The Great Grid Upgrade

Sea Link

Volume 9: Examination Submissions

Document 9.34.1: Applicant's Comments on Relevant Representations Identified by the ExA

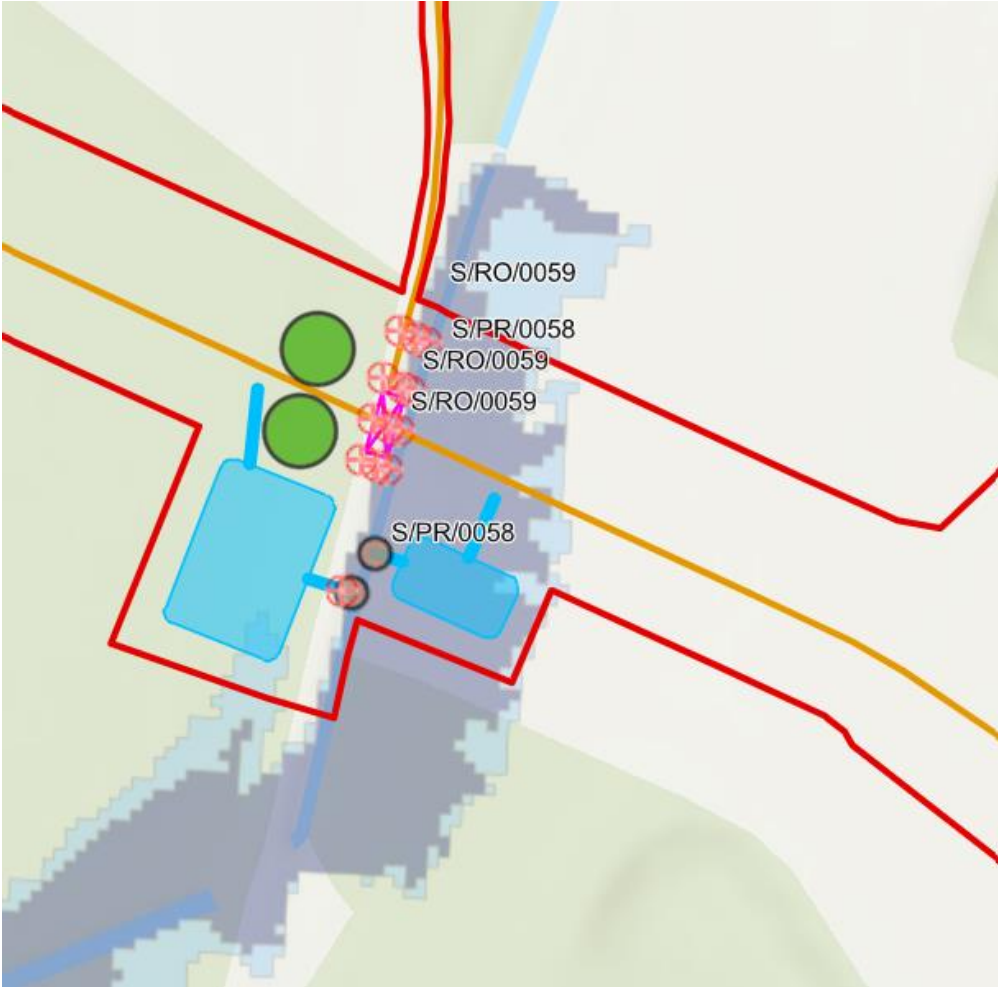
2.4.17. I	EA – HDD and flood defence monitoring ID: EA080 Environmental Statement APP-051 6.2.2.4 Part 2 Suffolk Chapter 4 Water Environment	Solution Integrate monitoring of settlement and monitoring of flood defences with consideration emergency triggers and actions. Include the Environment	Commitment W12 in Application Document 7.5.3.2 CEMP Appendix B Register of Environmental Actions and Commitments (REAC) [APP-342] states that: <i>“At the Suffolk and Kent landfalls the offshore cables will be brought onshore using a trenchless technique, avoiding physical disturbance of</i>

Reference	Summary of relevant representation	Recommendation	Applicant's response
	APP-292 6.8 Flood Risk Assessment Section/ pages/ table reference: 4.9.21 (APP-051) 4.3.23 (APP-292) Issue HDD surface level monitoring is not linked to monitoring of flood defence and emergency response. Impact Settlement may compromise defences and flood risk management.	Agency in the consideration of appropriate triggers and actions. These details should be submitted in a CEMP.	<i>several watercourses and areas of coastal floodplain. Monitoring of existing flood defences would be undertaken during the cable installation in agreement with Environment Agency protocols to ensure no detriment to the integrity of the defences."</i> This commitment provides the Environment Agency with the opportunity to influence the monitoring and to agree with the Applicant appropriate triggers and actions. However, the HDD at Kent is planned 20 m beneath the sea defences with the calculated worst-case long term settlement from the HDD as 3mm (<5 mm). Similarly the HDD at Suffolk is planned at 23 m beneath the existing natural coastal defences, with the calculated worst-case long-term settlement from the HDD of 3 mm (<5 mm). As such the level of settlement potentially induced by the HDDs is not of a scale that could impair coastal sea defences resulting in compromised defences and flood risk management. It is not therefore deemed necessary to monitor settlement, based on the WCS long term values cited.

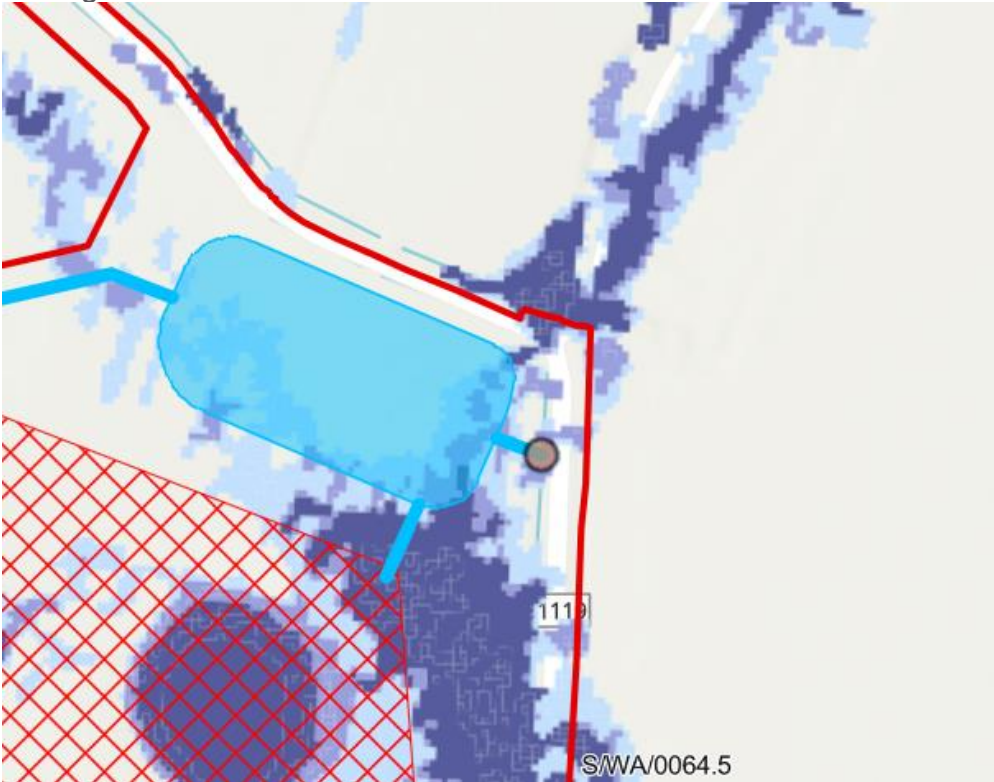
2.4.23.I	EA – Cofferdam location details ID: EA086	Solution	A commitment to not having a cofferdam within 8 m/16 m of flood defence is acceptable. Where required, an update to Application Document 7.5.3.2 CEMP Appendix B Register of Environmental

Reference	Summary of relevant representation	Recommendation	Applicant's response
	Environmental Statement APP-045 6.2.1.4 Part 1 Introduction Chapter 4 Description of the Proposed Project Section/ pages/ table reference: 4.6.172-4.6.174 Issue Unclear as to the exact location of temporary cofferdams at HDD exits. Impact May impact the stability or preclude access to flood defences/banks of a main if located nearby.	Confirmation or details of cofferdam locations to be submitted to ascertain exact location. Additional comments: A FRAP will be required for any works within 8m of a fluvial river/flood defences, or 16m for a tidal river/flood defences.	Actions and Commitments (REAC) [APP-342] will be made following further agreement between the Applicant and Environment Agency. Also note, cofferdams are temporary structures for use during construction only

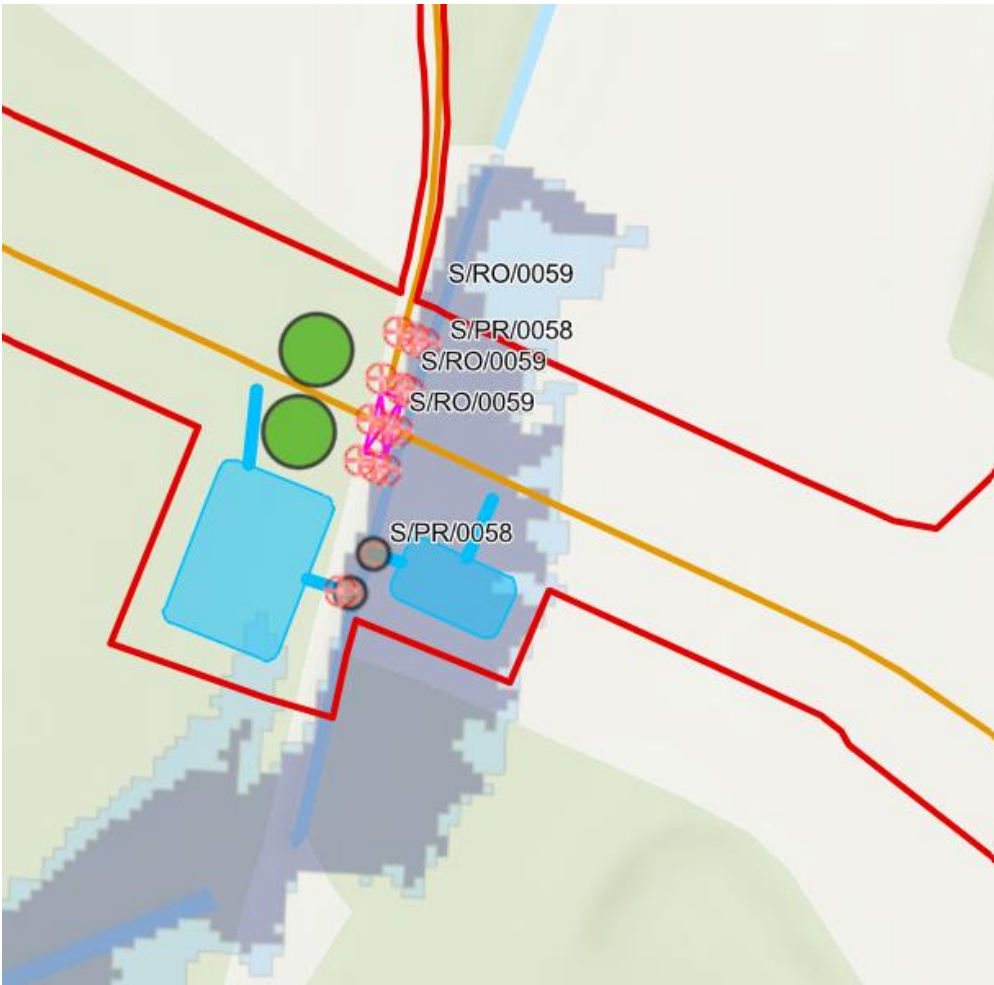
2.4.26. I	EA – River Stour material storage ID: EA089 Environmental Statement APP-292 6.8 Flood Risk Assessment Section/ pages/ table reference: Table 1.1 Issue	Solution Confirmation as to locations on where this may be required, and what the mitigations will be. These details should be submitted in a CEMP.	The Proposed Project is looking to use trackway within the flood zone in Kent to access the tower locations, however topsoil striping and stockpiling will still be required as will sub soil stockpiling at the tower locations. These stockpiles will be isolated so as not to create a barrier to the flow of flood water. The temporary bridge crossing will also require ramped approaches. A flood risk activity permit application will be submitted by the contractor for these activities. The photograph

Reference	Summary of relevant representation	Recommendation	Applicant's response
	Omission of details regarding mitigation for storage of materials within the River Stour floodplain. Impact Potential to alter or impede flood flow paths and thereby increase flood risk.	Awareness that a FRAP will be required if it is not possible to remove any storage areas outside of the floodplain. Additional comments: It is accepted and noted within the FRA that no construction materials are to be stored within Flood Zone 3 (W06), however it later explains that this may not be possible in the River Stour Floodplain and mitigation measures will be applied. Any activity (other than an allowed activity) on a floodplain can be considered a Flood Risk Activity under Definition G of Schedule 25 of the EPR (2016) legislation if the work is likely to divert or obstruct flood waters. Excavation or changes in ground level has the potential to do so. A Flood Risk Activity Permit will need to be applied for.	below shows similar trackway, isolated stockpiles and ramps used for the Canterbury to Richborough project.  Commitment W06 secures mitigation where storage of materials cannot avoid Flood Zone 3. Examples include using model outputs to inform the placement of soil during construction and aligning soil stockpiles to avoid impeding key flood flow routes. Given that the River Stour is a tidally dominated river within the Order Limits, in accordance with the guidance that accompanies the National Planning Policy Framework compensation for losses of floodplain storage are not required. This has also been previously agreed with the Environment Agency.
